In the Matter of
Hearing Stream 13 - Queenstown Mapping

Submission 131 / Further Submission 1293

Statement of Joanna Taverner
Dated 09 August 2017

**FIGURE 12 -
POTENTIAL TO ABSORB CHANGE**

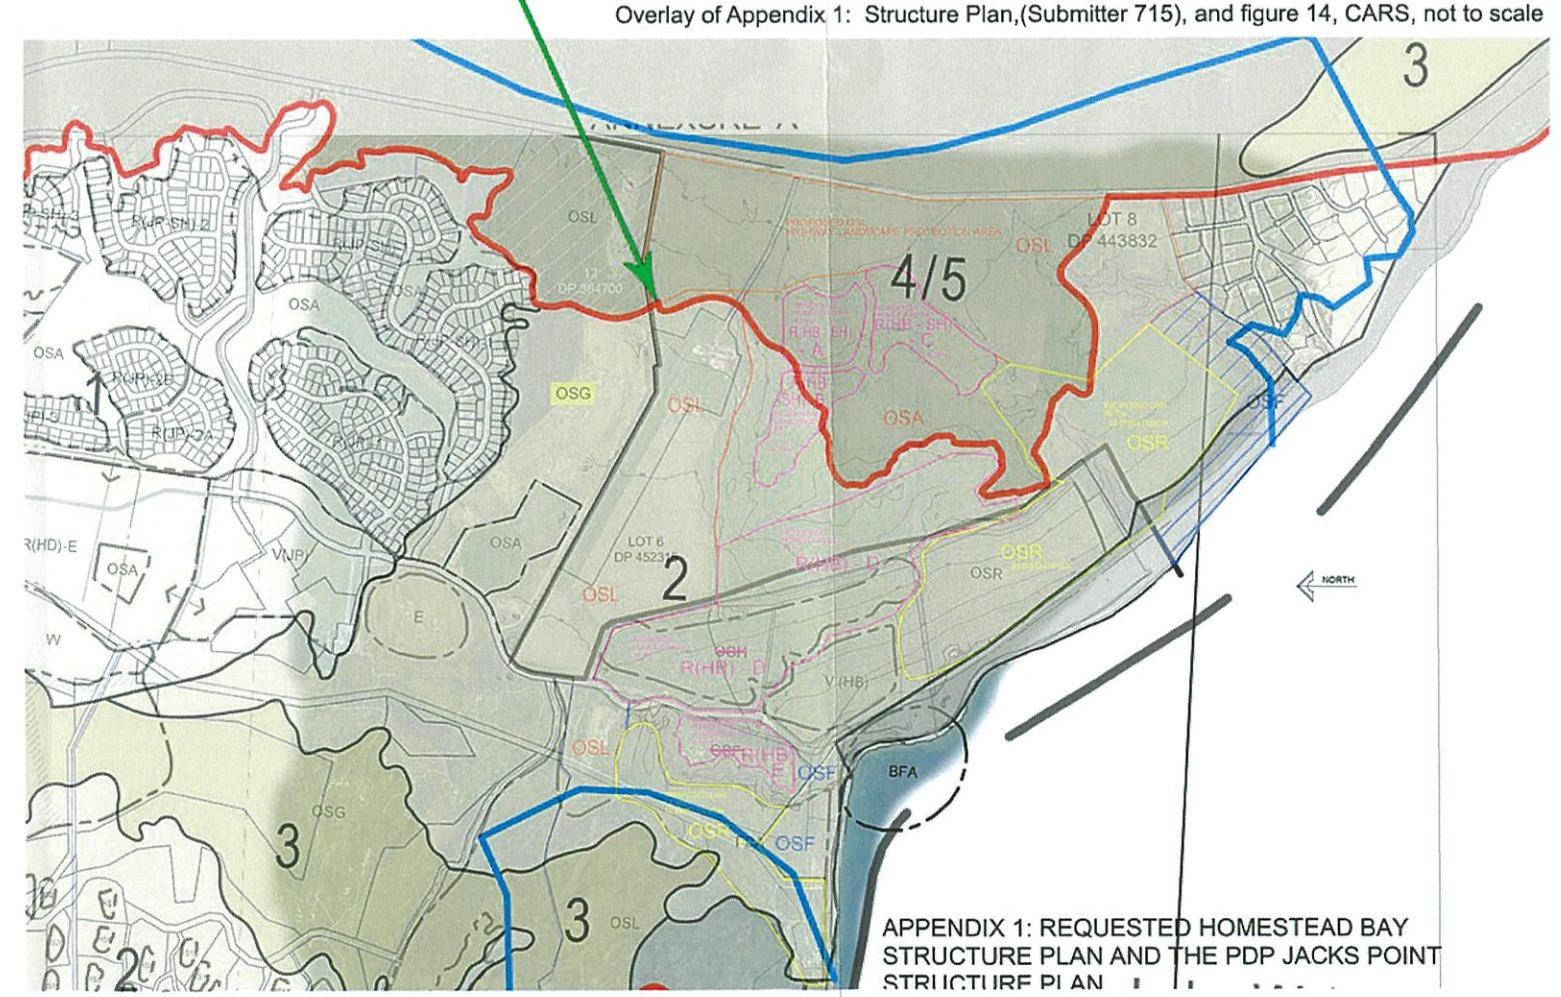
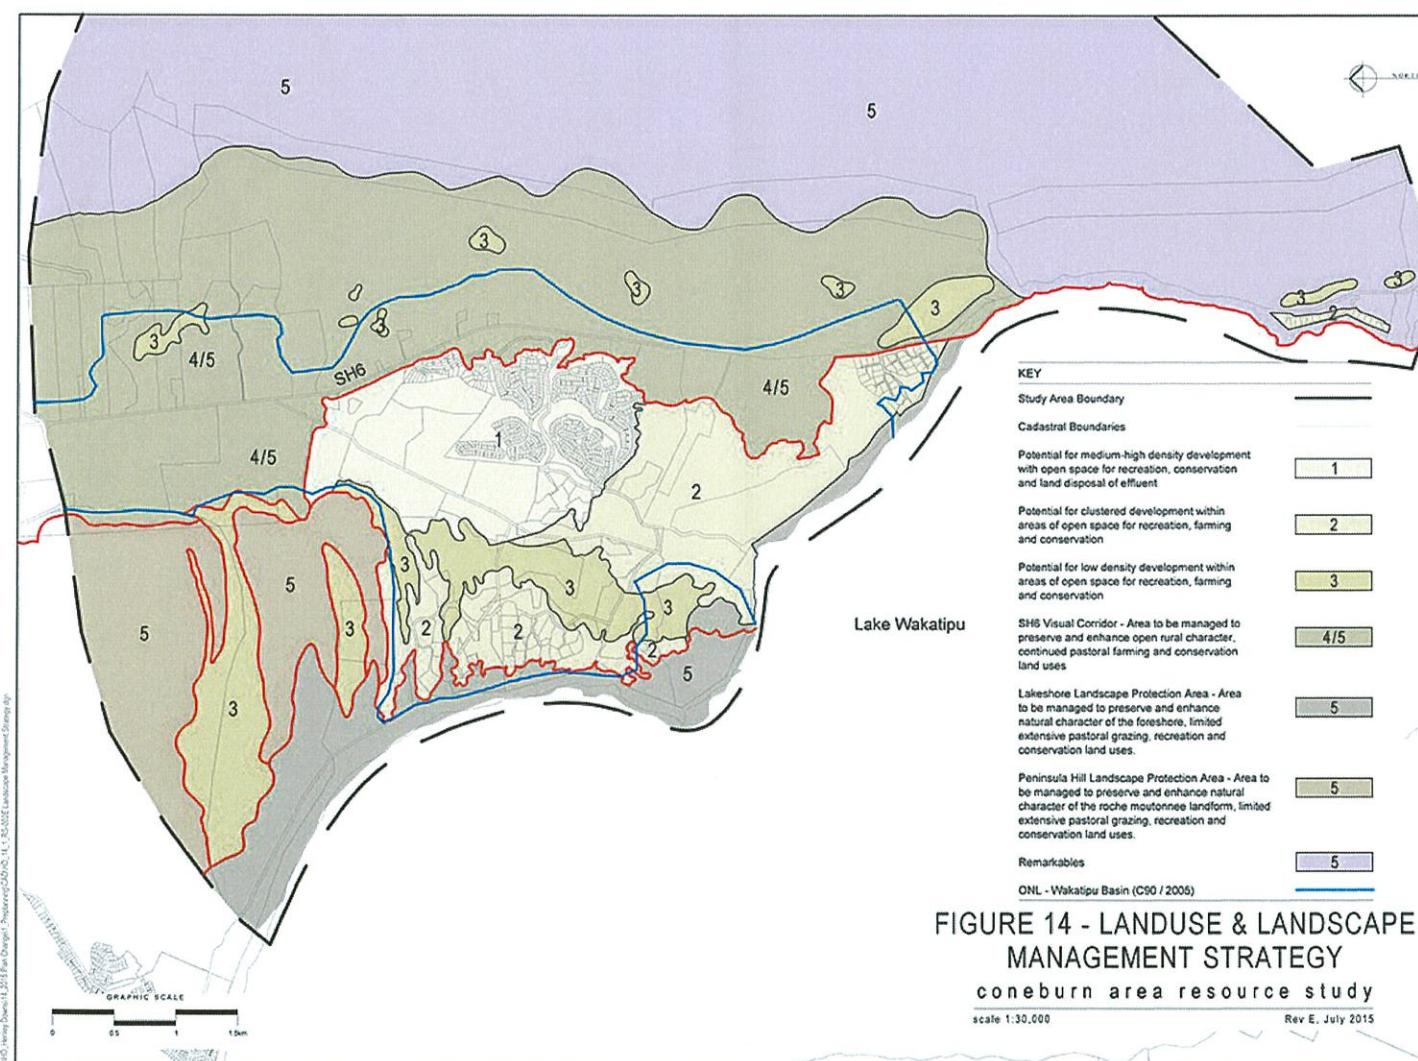
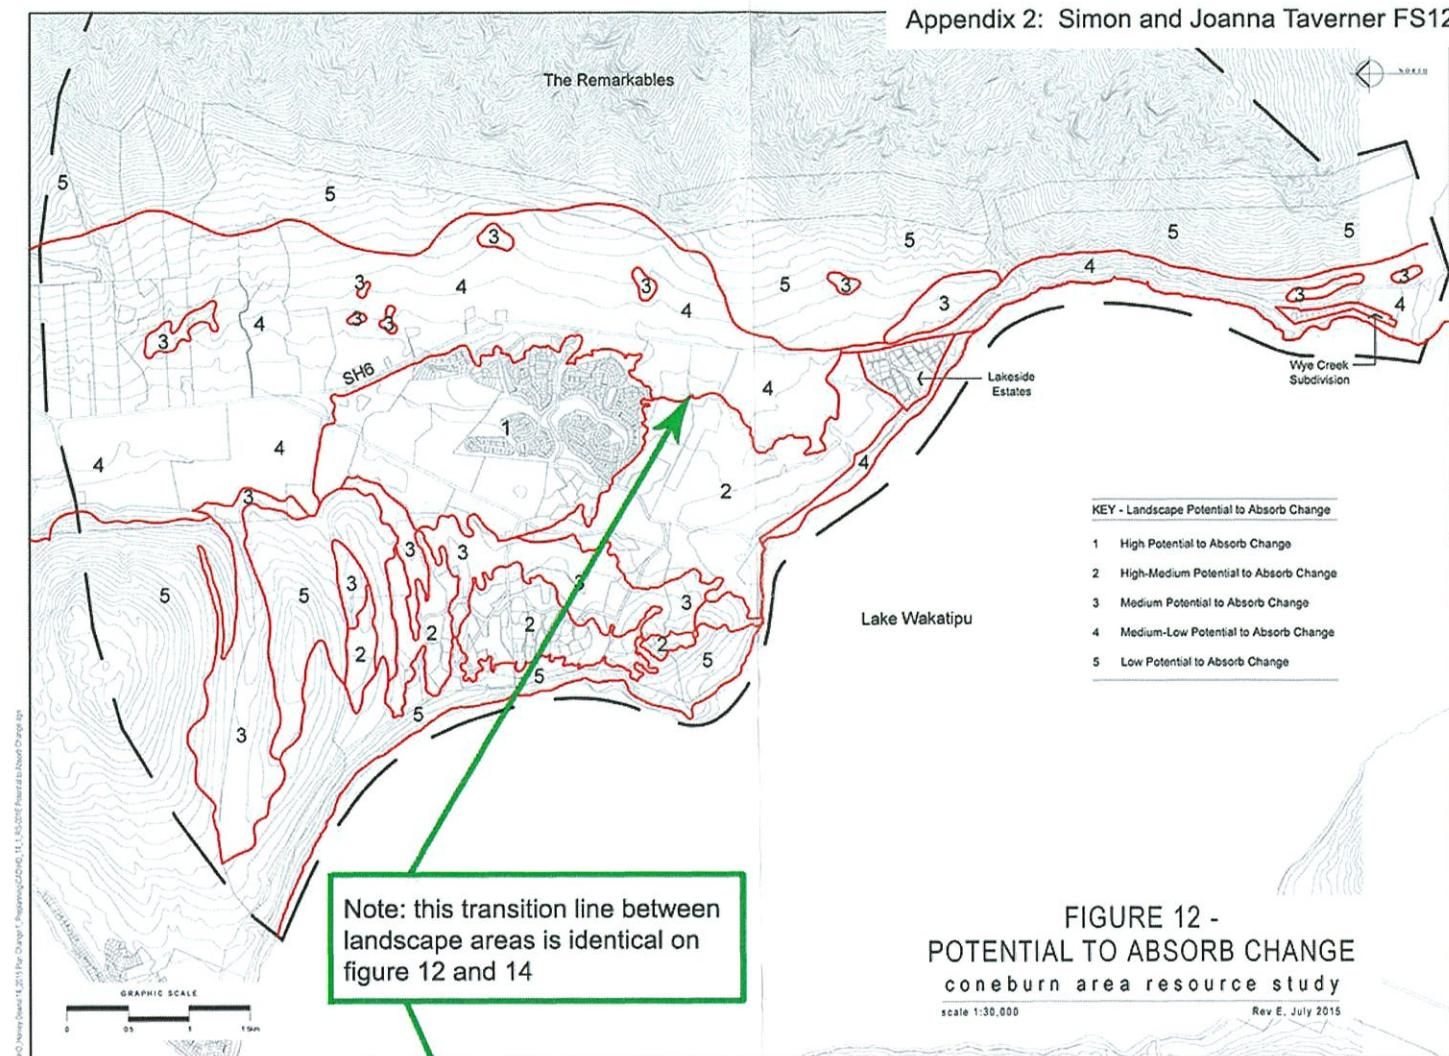
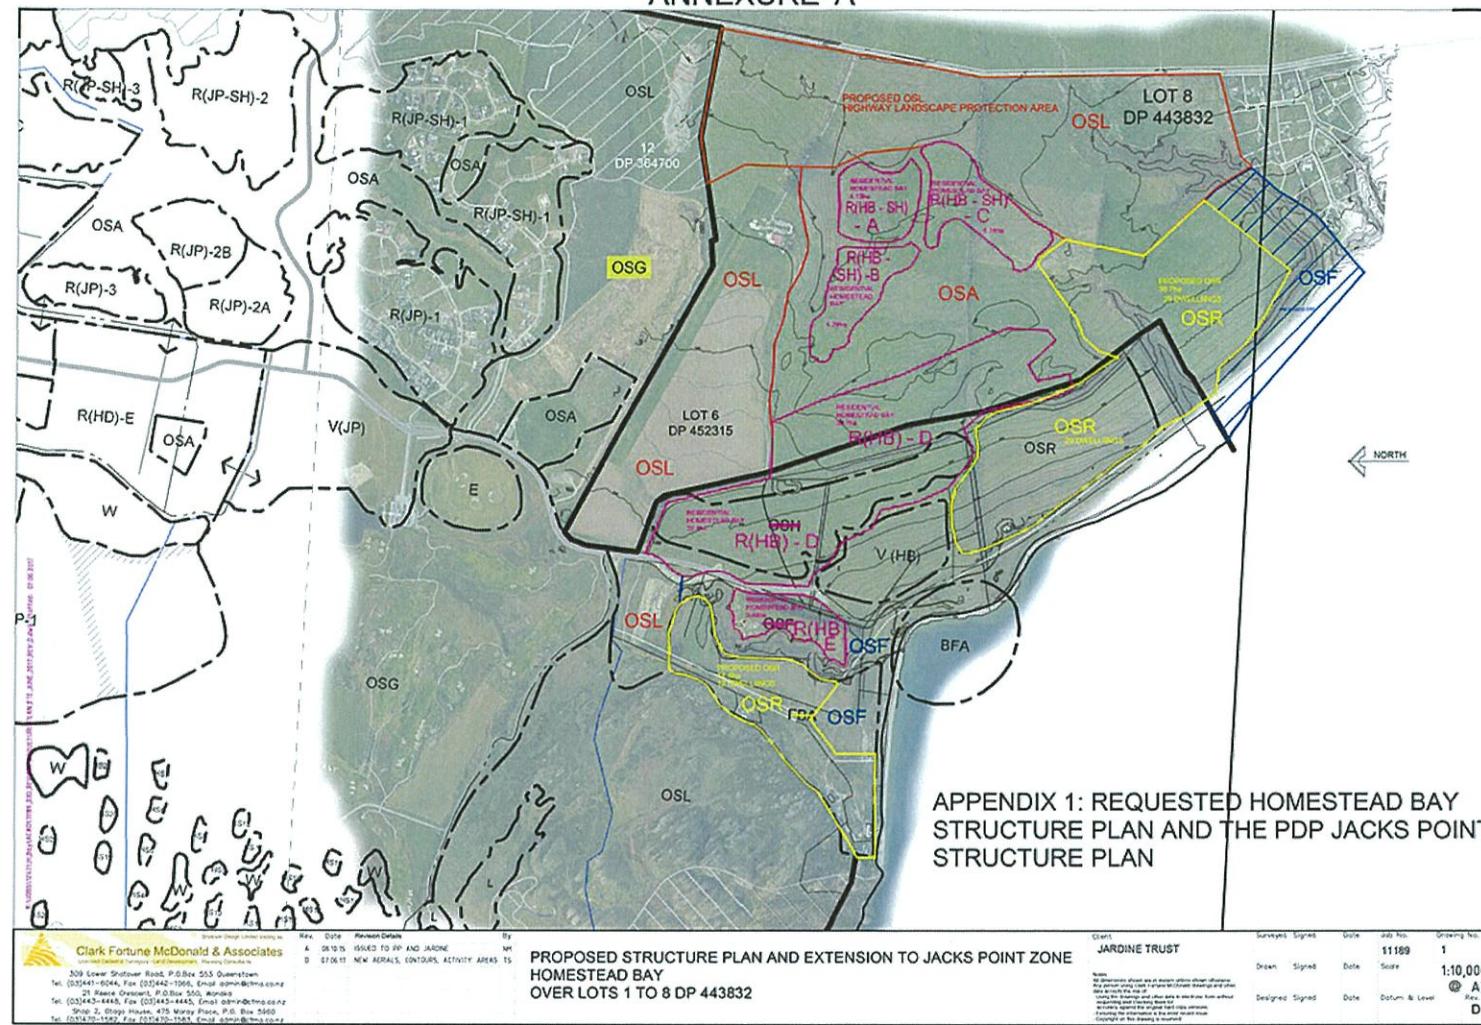
6. The CARS Figure 12 ranks areas within the catchment on a five point scale with 1 having the highest and 5 having the lowest ability to absorb change. Figure 14 provides the conclusion to the study², identifying future Landuse and Landscape Management Strategies. I have overlaid figure 14 onto the applicant's proposed Structure Plan³ attached as Appendix 2. Areas R(HB-SH) A and C, part of B and part of the extended OSR fall within an area designated as 4 on the scale on Figure 12, with a 'medium-low potential to absorb change', and on Future Landuse figure 14 as "SH6 Visual Corridor - area to be managed to preserve and enhance open rural character, continued pastoral farming and conservation land uses". The transition line between the recommended landuse zones (shown in red) is a response to visibility and topographical changes, with the higher gently sloping paddocks close to the road considered inappropriate for development. The study recognises and places importance on the presence of rural farming land adjacent to SH6 on the transition into and out of Queenstown.

7. Development of the Homestead Bay extension in the manner proposed by submitter 715 is contrary to the recommendations of this study, the conclusions of which have been based on a thorough, layered and comprehensive analysis of the landscape.

Taverner Evidence, Attachment 3: Section magnified x2 and vertical scale applied

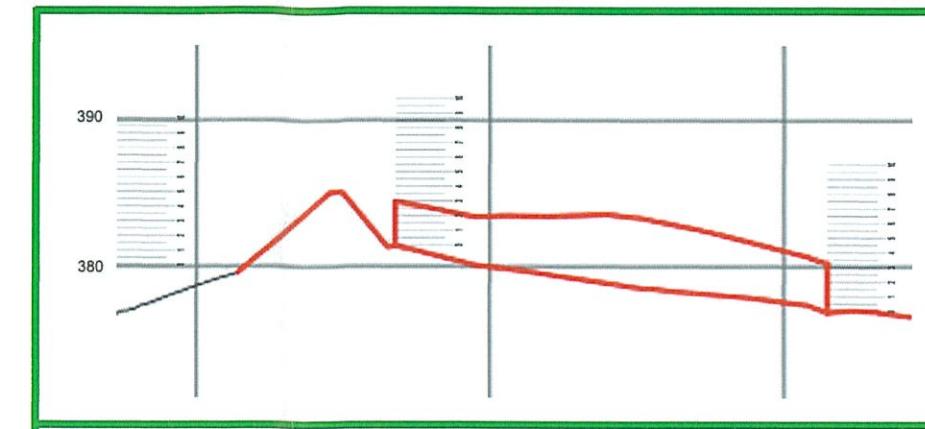
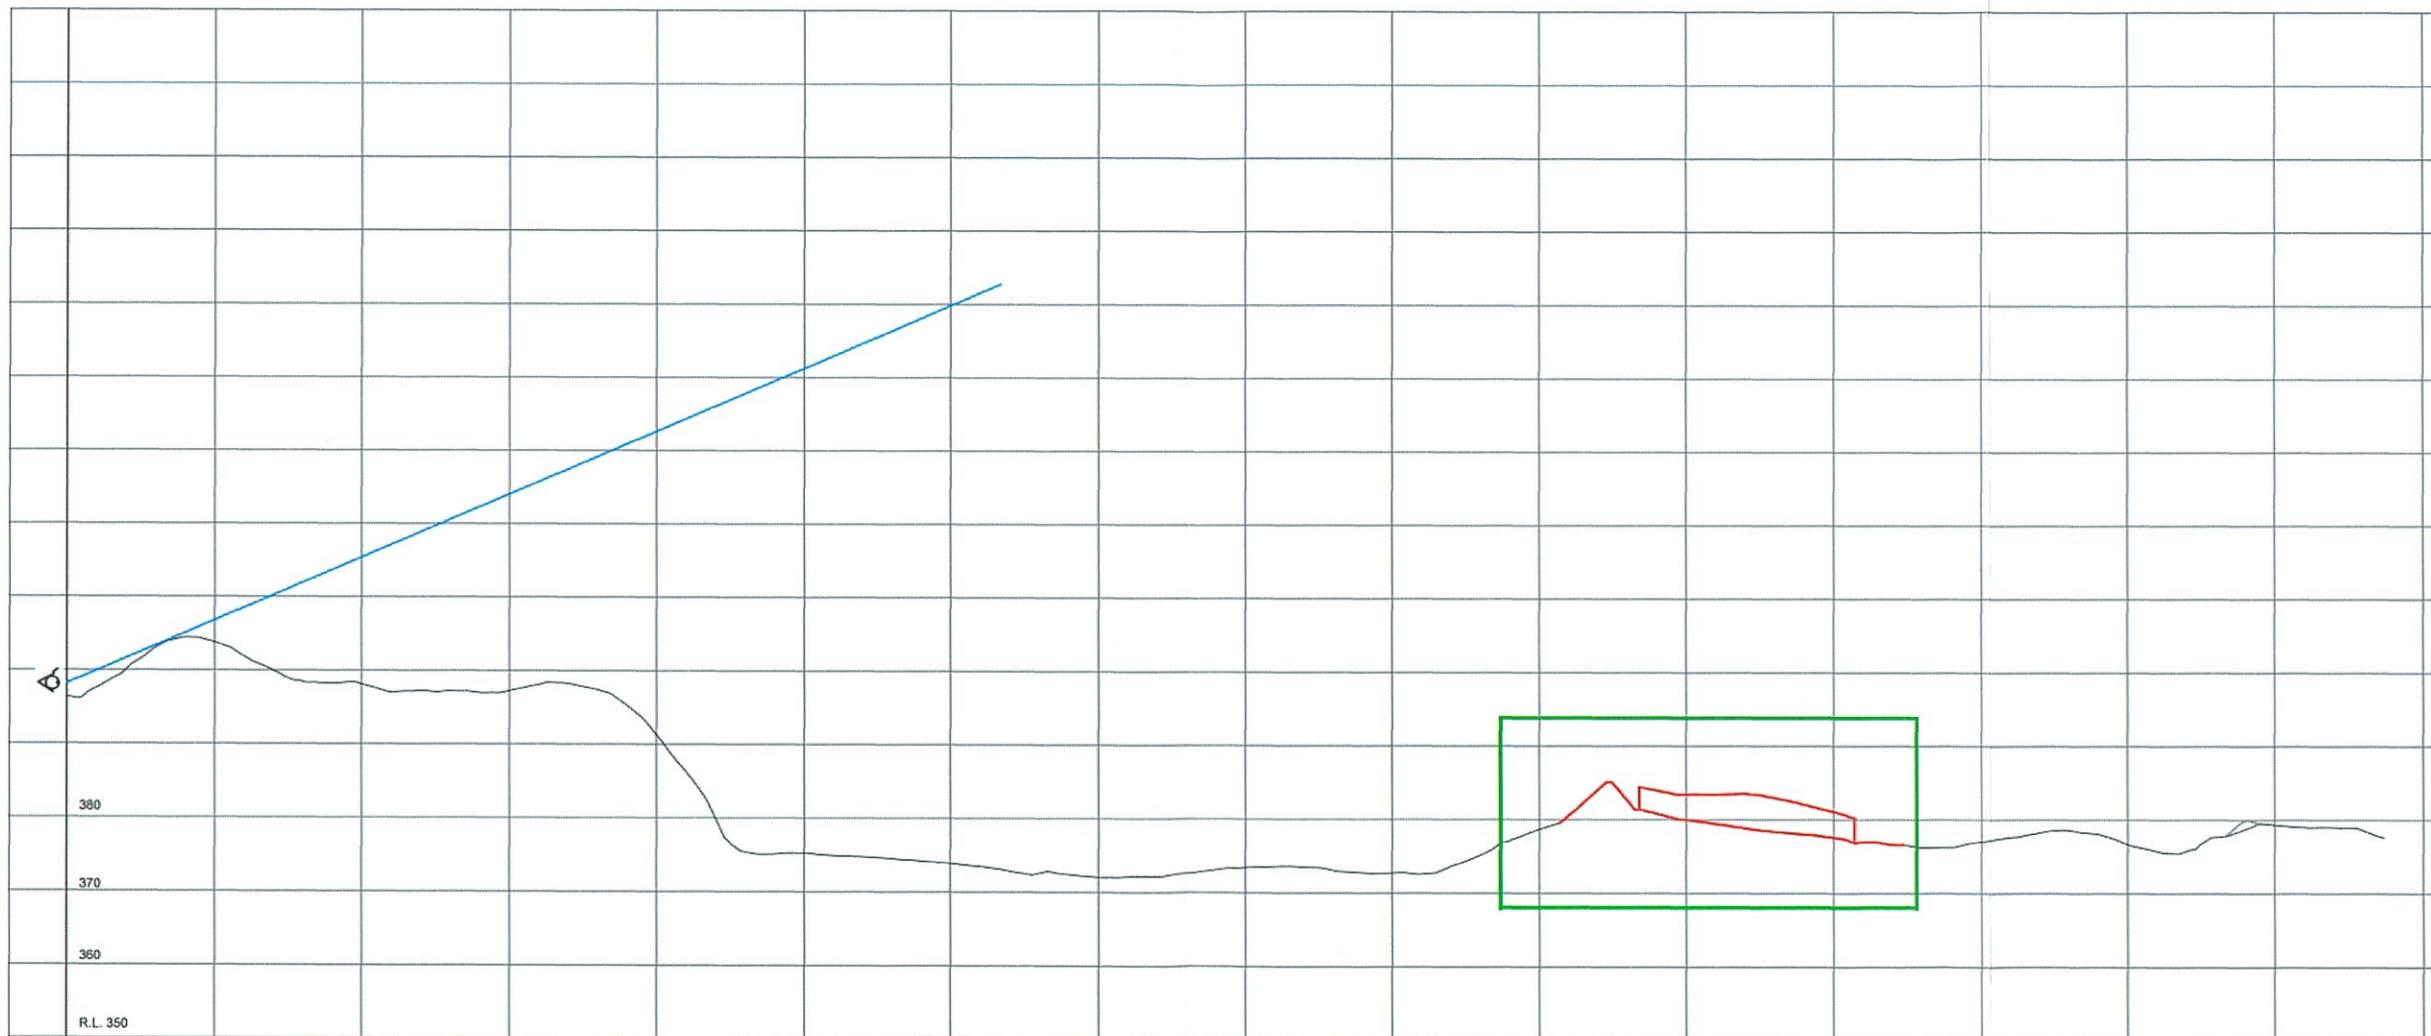
- b. The cross sections have a vertical scale five times larger than the horizontal scale (not noted on the plans), giving a skewed interpretation of the proposed mounding and extent of developed area. Although Mr Espie notes these cross sections are 'crude' he states that the vertical height is correct.

- c. When scaling vertically from the cross sections, building height is shown at approximately 3.2m high on Sections G and E, approximately 3.5m high on Section A and C, and under 5.0m high on section D, attached as Appendix 3 to this evidence. At best a 5m high building height is difficult to achieve, with most single level houses having ridgelines of 5.5 - 6m on a flat site. A 3.2m high building is not practical so I assume this is incorrect. See Attachment 3.

- d. I cannot find a proposed building height limit for the extension areas in the evidence, only an assurance that the screening would be sufficient to completely hide the houses by including rule 41.5.12.2(l)¹⁰. However I consider that the building height would need to increase, certainly where it is shown as only 3.2m, and therefore the mounding will need to be increased to screen this. This further compounds the negative effects of unnatural landforms imposed on a gently sloping topography, and further restricts any views across the site. Essentially the earthworks 'walls' built around the development will need to be increased.
